DURHAM COUNTY

I-40 and Miami Blvd.

Date: April 4, 2017	County: Durham
Interchange: I-40 and Miami Blvd.	
Location (exit ramp): EB Exit Ramp

I-40 EB Exit Ramp at Miami Blvd.

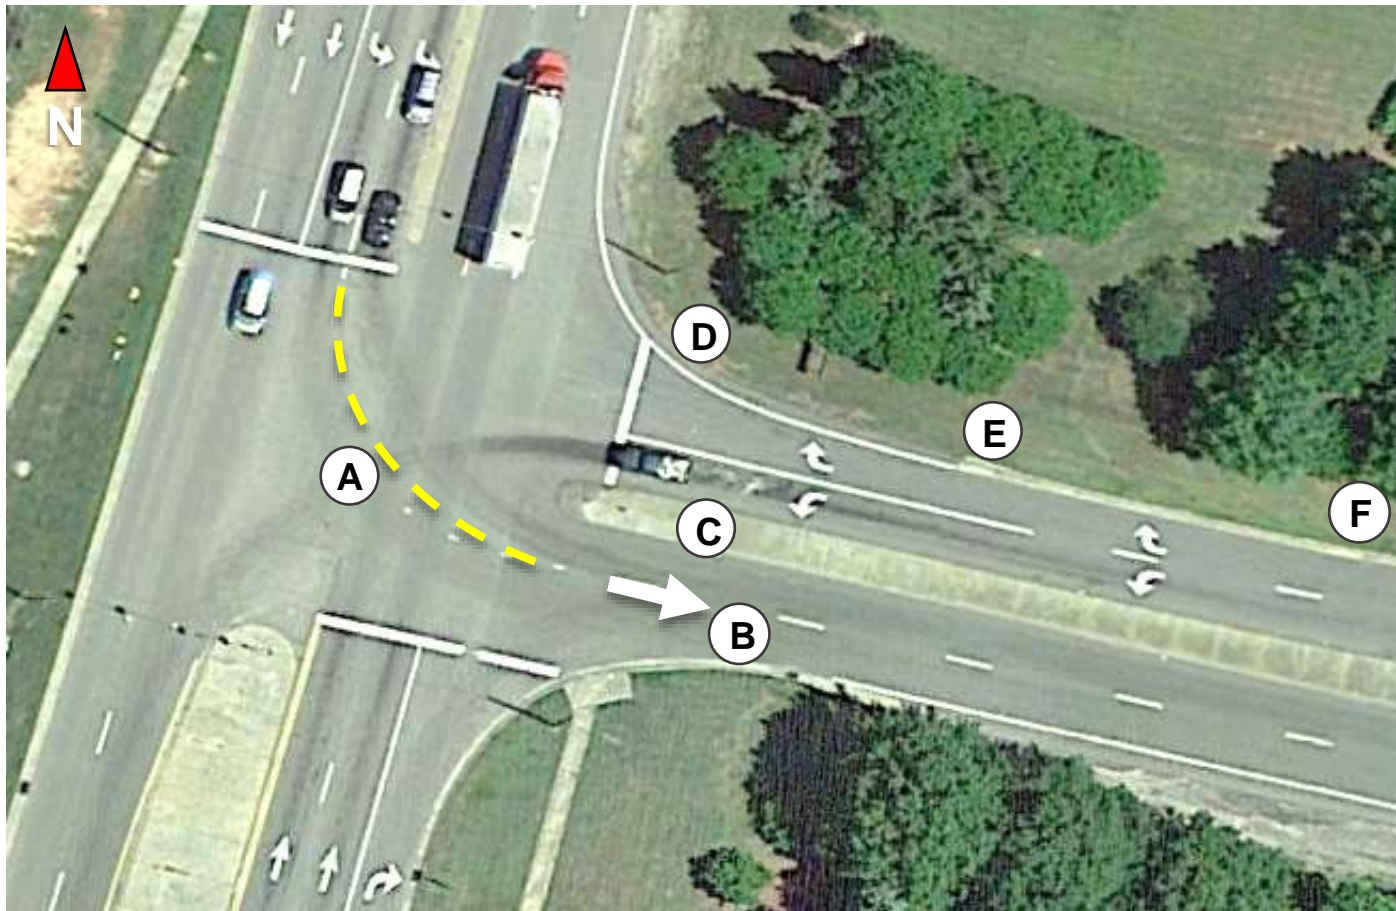
- A. Add dotted lane line extension through intersection
- B. Add arrow indicating correct freeway entrance point
- C. Install larger island splitter sign
- D. Add Do Not Enter sign
- E. Add Wrong Way sign
- F. Add Wrong Way arrows

I-85 NB Exit Ramp at E. Club Blvd.

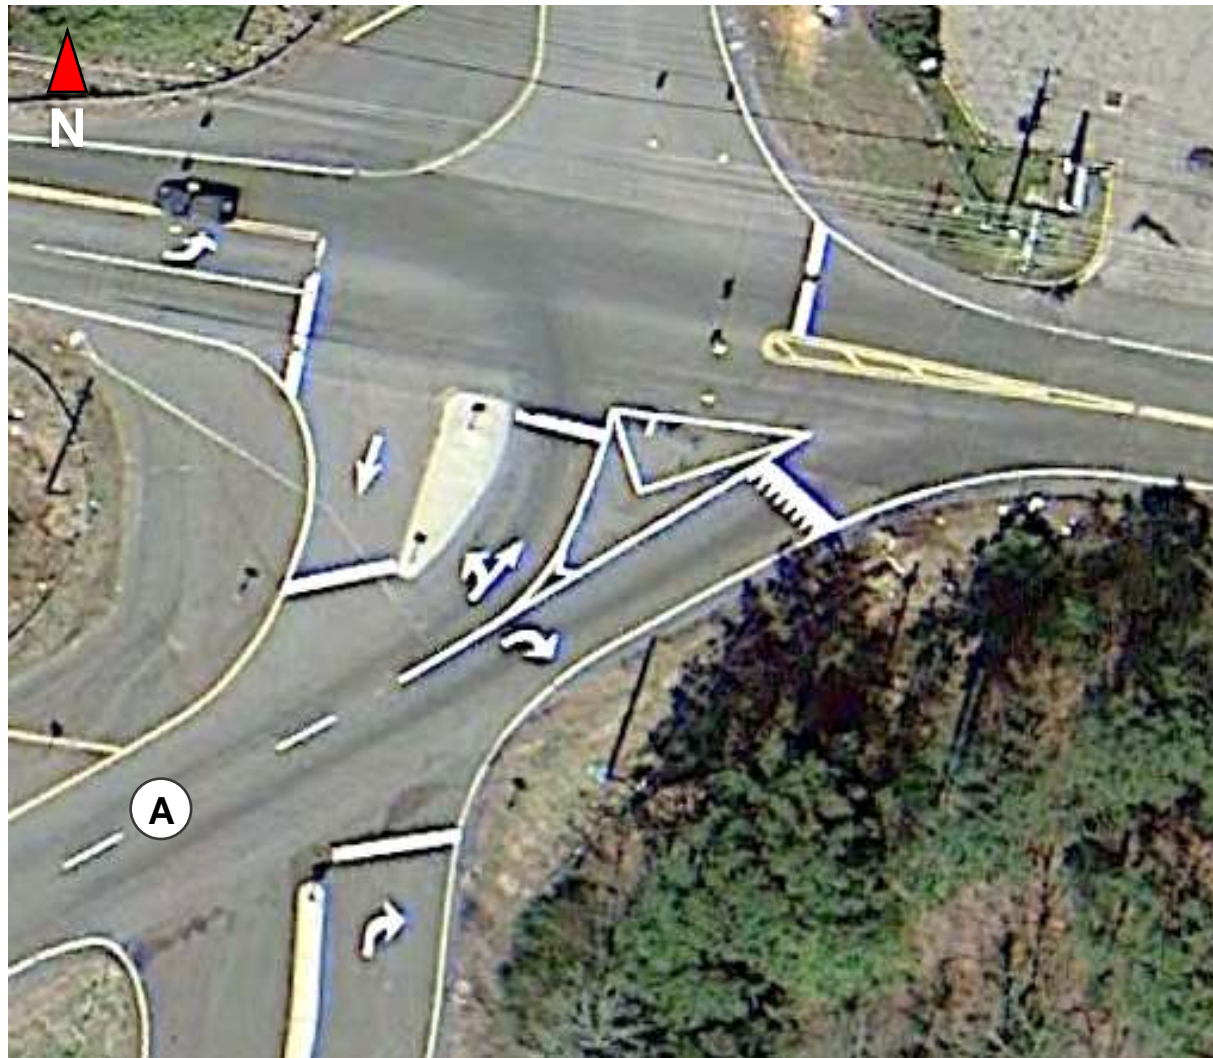
This exit ramp terminal is strangely and potentially dangerously configured, in that it allows a movement onto the ramp that is counterflow to most of the ramp. This movement is apparently to provide access to the private driveway that accesses the ramp. This counterflow movement is accentuated by the placement of a pavement arrow which seemingly directs drivers to enter the exit ramp.

A. Add Wrong Way arrows

US 70 EB Exit Ramp at Cheek Rd.

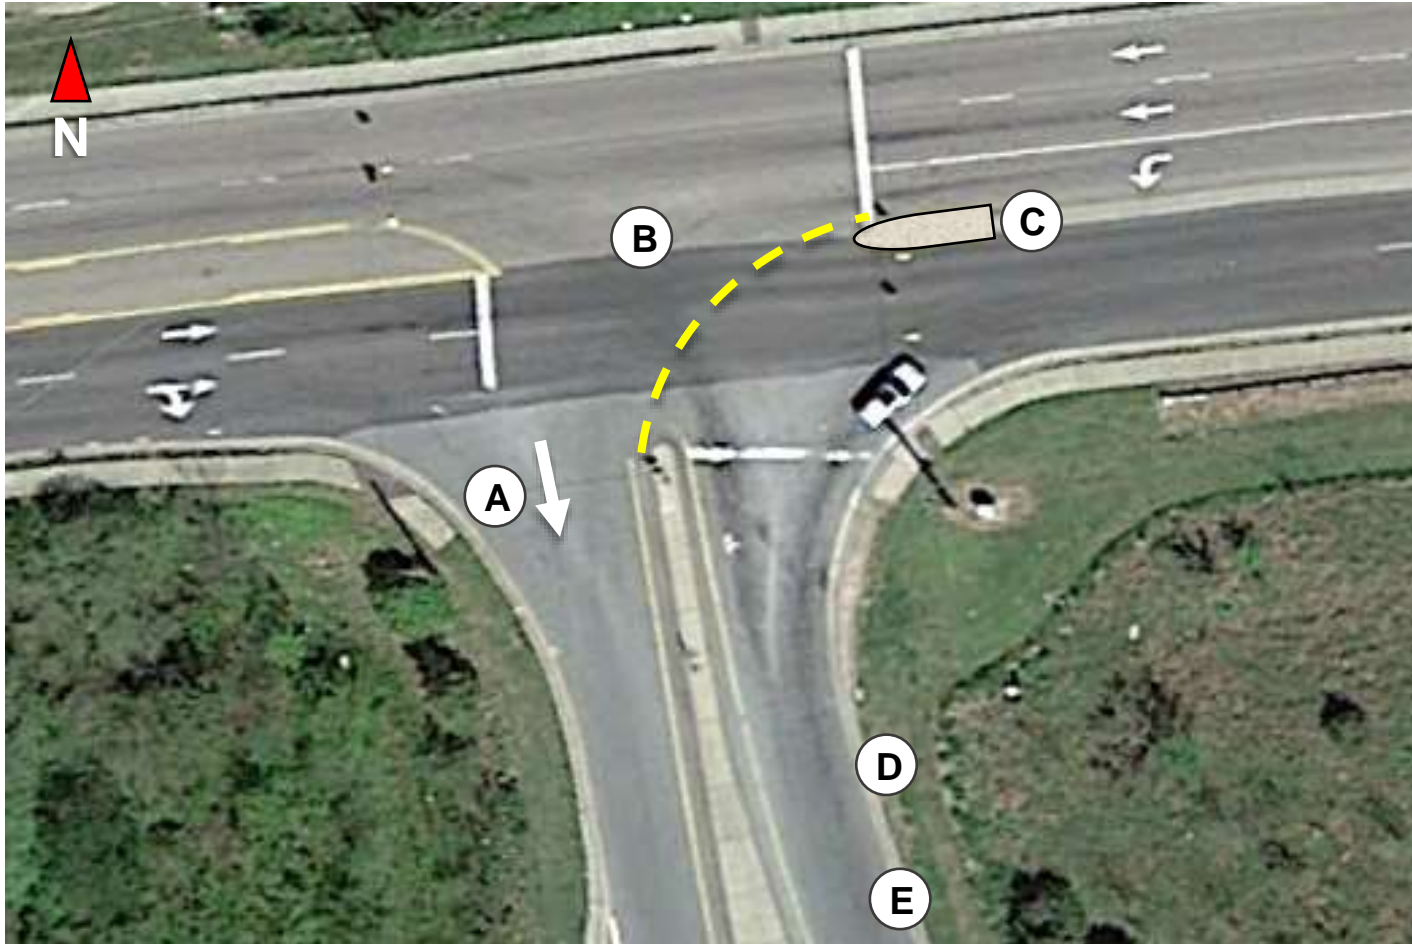
- A. Add arrow indicating correct freeway entrance point
- B. Add dotted lane line extension through intersection
- C. Extend raised median
- D. Add Wrong Way sign
- E. Add Wrong Way arrow

US 70 WB Exit Ramp at Holloway St.

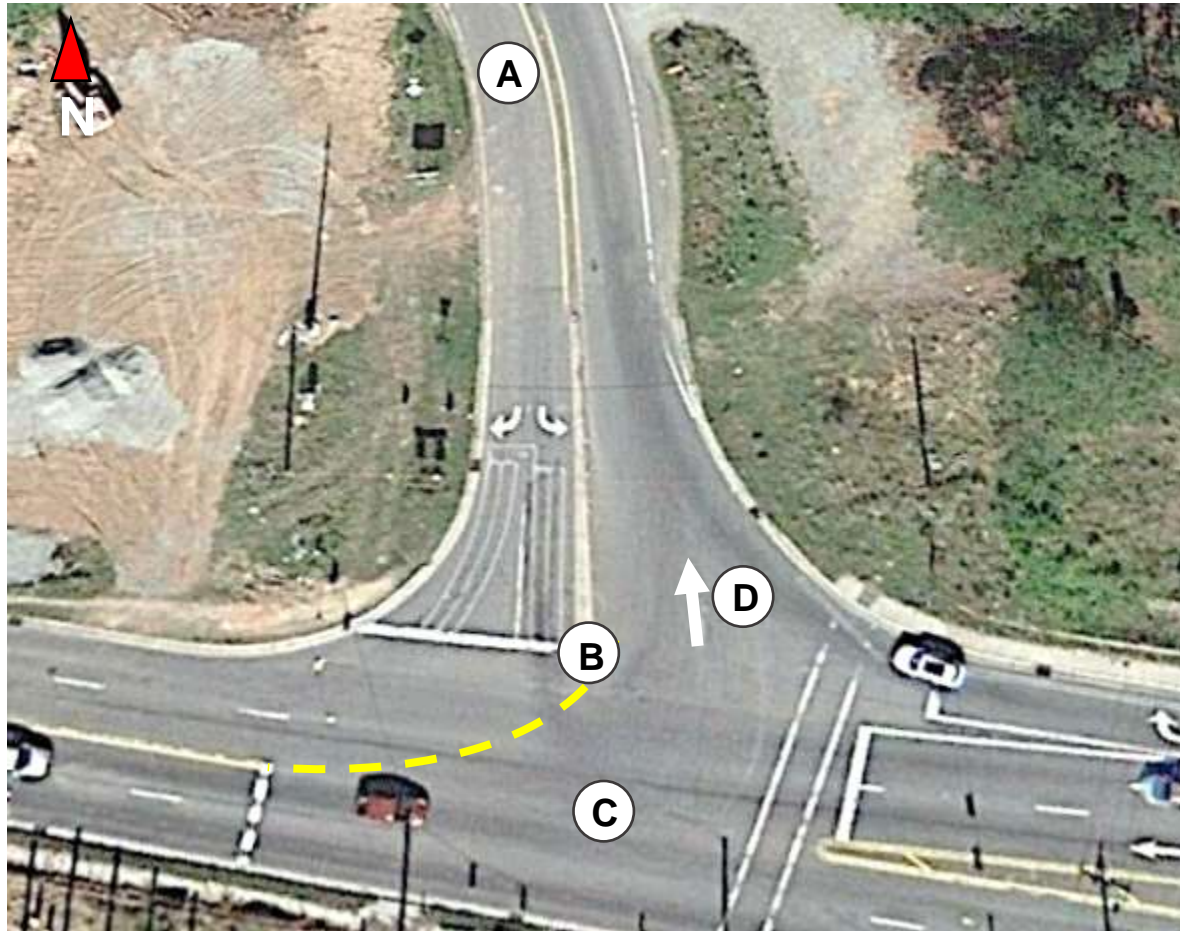
Sight line clutter – buildings, overpass, and signs converge, creating heavy visual stimuli

Improve visibility of the median on the exit/entrance ramp

- A. Add wrong way arrows
- B. Improve median visibility, add splitter sign
- C. Add dotted lane line extension through intersection
- D. Add arrow indicating correct freeway entrance point

I-40 EB Exit Ramp at Fayetteville Rd.

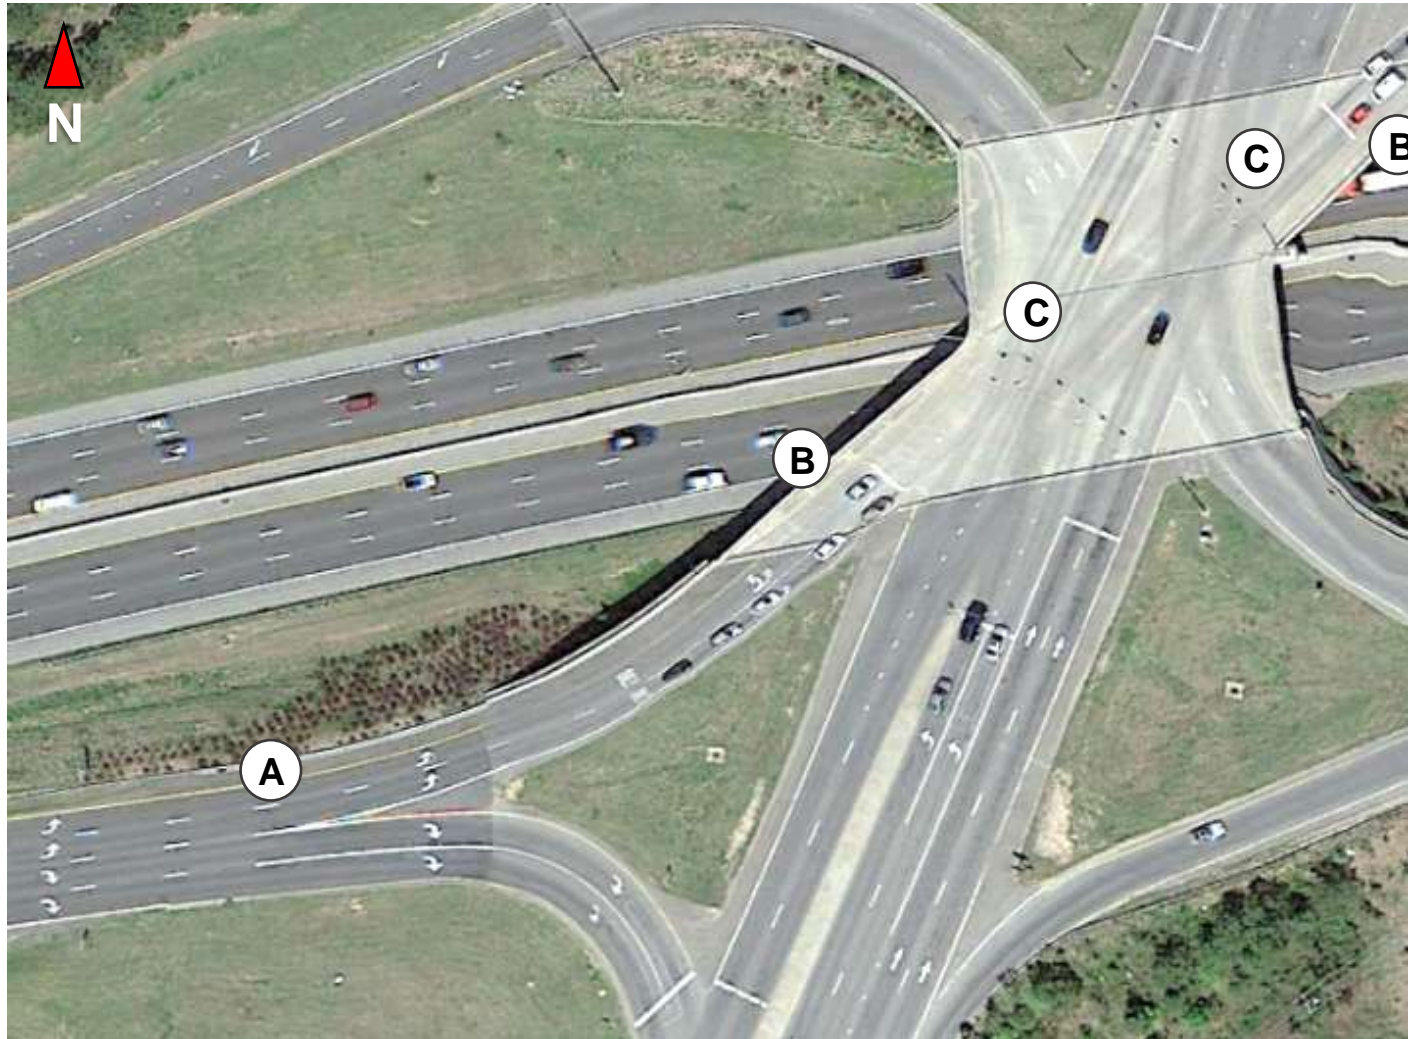
Some form of overhead 'Do Not Enter' sign may be appropriate above the directional lanes of the exit ramp. These could be similar to the static metal signs (i.e., circular with the words "Do Not Enter"), or could be configured as red X's, similar to the type of signs used on roads with changeable direction lanes.

- A. Add Wrong Way arrows
- B. Add Wrong Way signs
- C. Add overhead signs to indicate 'No Entry'

I-40 Bus. EB Exit Ramp at Cloverdale Ave.

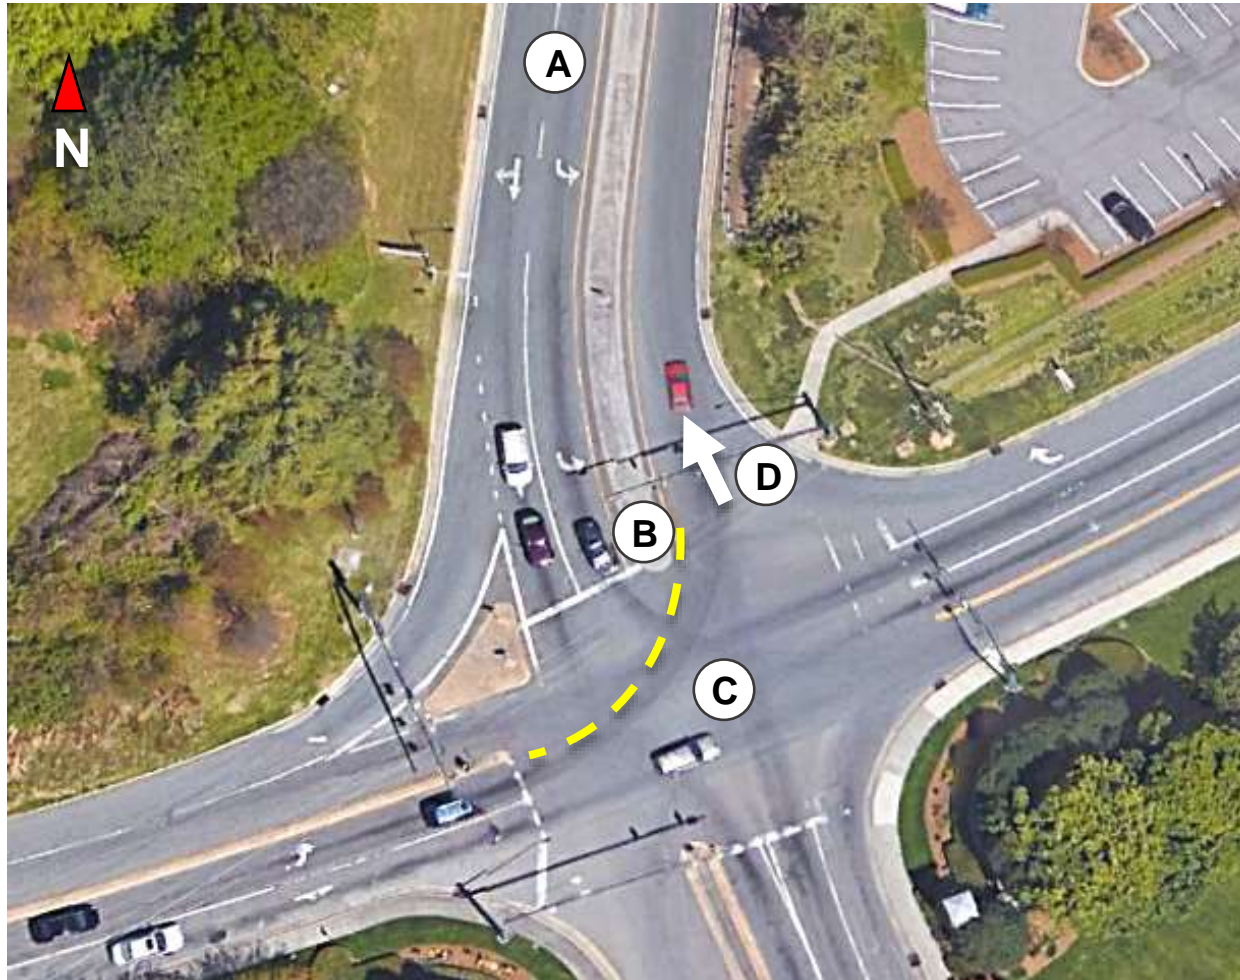
Low potential for right turn wrong-way movement. Left turn wrong-way movement has some potential.

- A. Add Wrong Way arrows**
- B. Add reflectors and improve visibility of median**
- C. Add dotted lane line extension through intersection**
- D. Add arrow indicating correct freeway entrance point**

I-40 Bus. WB Exit Ramp at Cloverdale Ave.

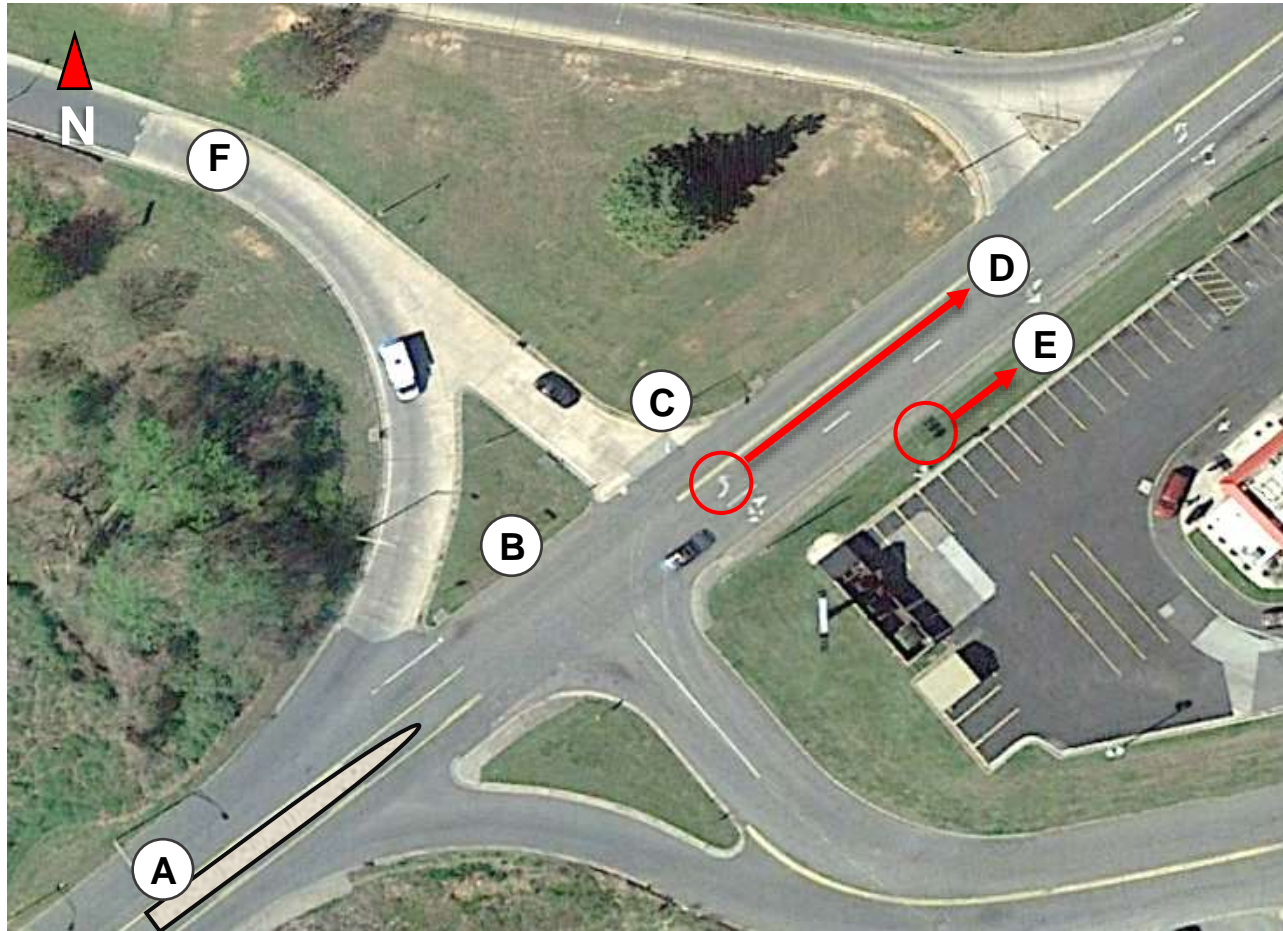
When approaching Northbound on Cloverdale, a driver may not see that the entrance ramp is up ahead (i.e., they only see the exit ramp). Route sign placement does not help (i.e., too close to the exit ramp).

- A. Add raised median to prevent wrong-way entry
- B. Add No Left Turn sign
- C. Tighten corner radius, repaint stop bar, add No Right Turn sign
- D. Remove turn arrow (misleading), move closer to entrance ramp
- E. Move route sign closer to entrance ramp (misleading)
- F. Add Wrong Way arrows

I-40/US 421 EB Exit Ramp at NC 66

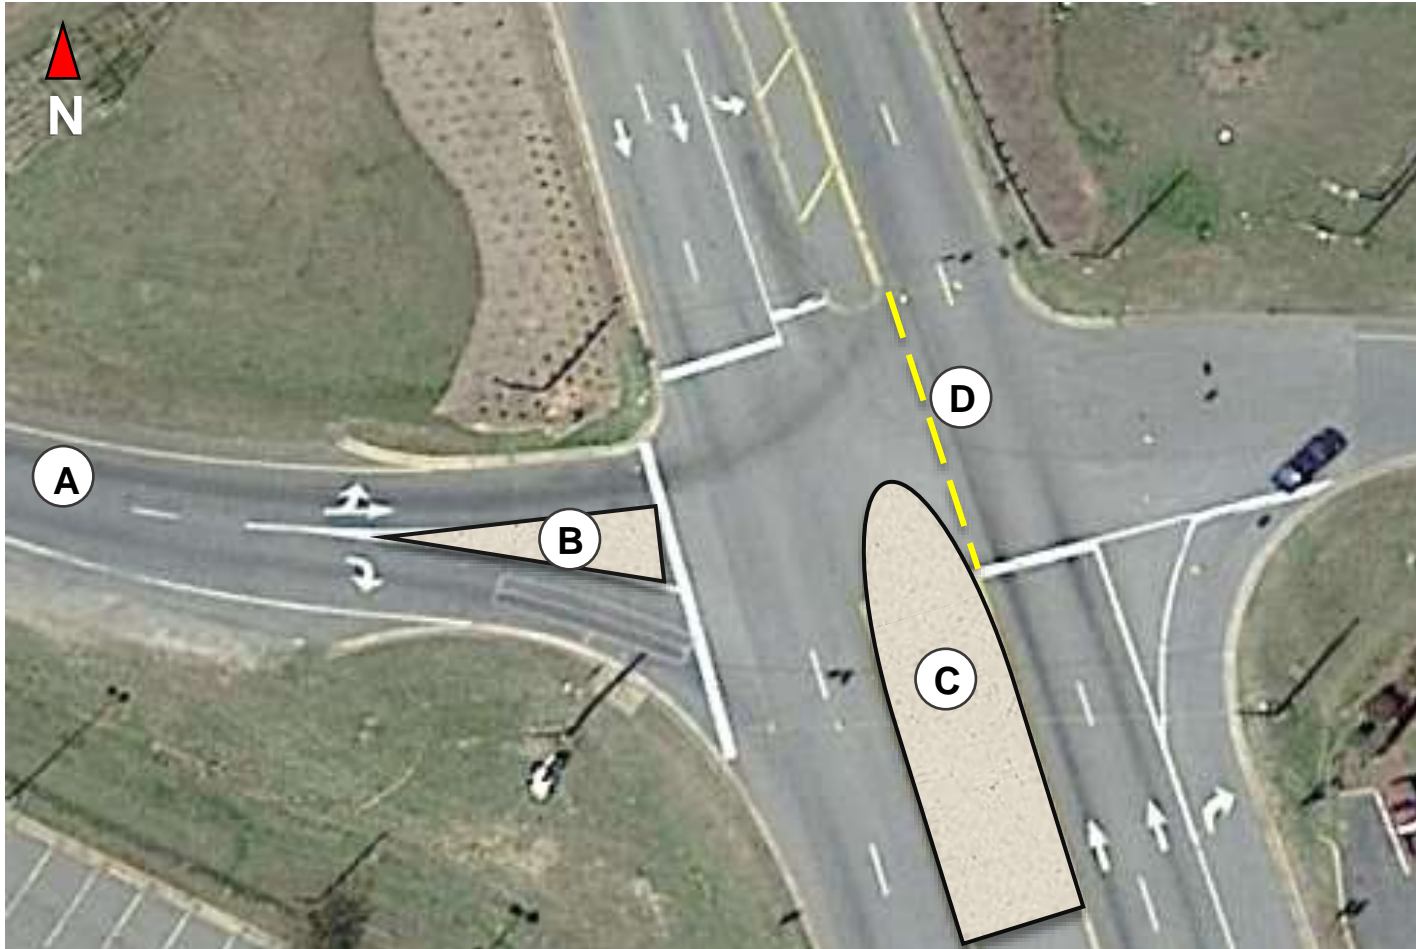
The strongest recommendation at this site would be to incorporate a raised median on NC 66, extending out into the intersection to reduce the possibility of left turns into the exit ramp.

Installing dashed guide lines along the left lane of NC 66 through the intersection may help reduce wrong-way left turn movement.

- A. Add Wrong Way arrows
- B. Add raised splitter island
- C. Add short raised median
- D. Add dashed guide lines
